**Approval of “LABETA” Flush Valve
(General Acceptance No. C20180763F)**

Model: LA-388

General Acceptance No. C20180763F

LA-388

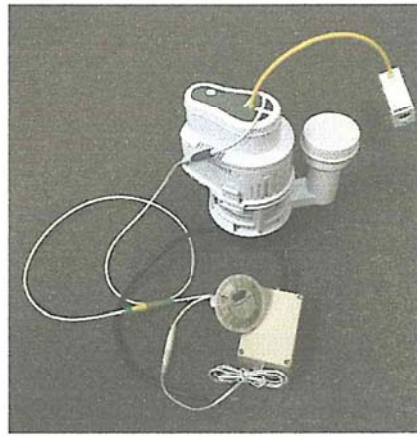
This Authority hereby permits the use of the above fitting in flushing water plumbing systems subject to full adherence to Waterworks installation requirements. In particular, you are required to draw your customers' attention to the following requirement-

"The flushing volume of the flushing valve should be adjusted to suit the design of the toilet bowl so that wastes can be cleared effectively by a single flush."

"The maximum flushing cistern volume including that of dual flush cisterns for use in conjunction with the fitting shall not exceed 7.5 litres per flush."

"The fitting should be used within the range of working pressures specified by the manufacturer." AND

"The installed fitting should not result in backflow of water that will contaminate the flushing water supply."
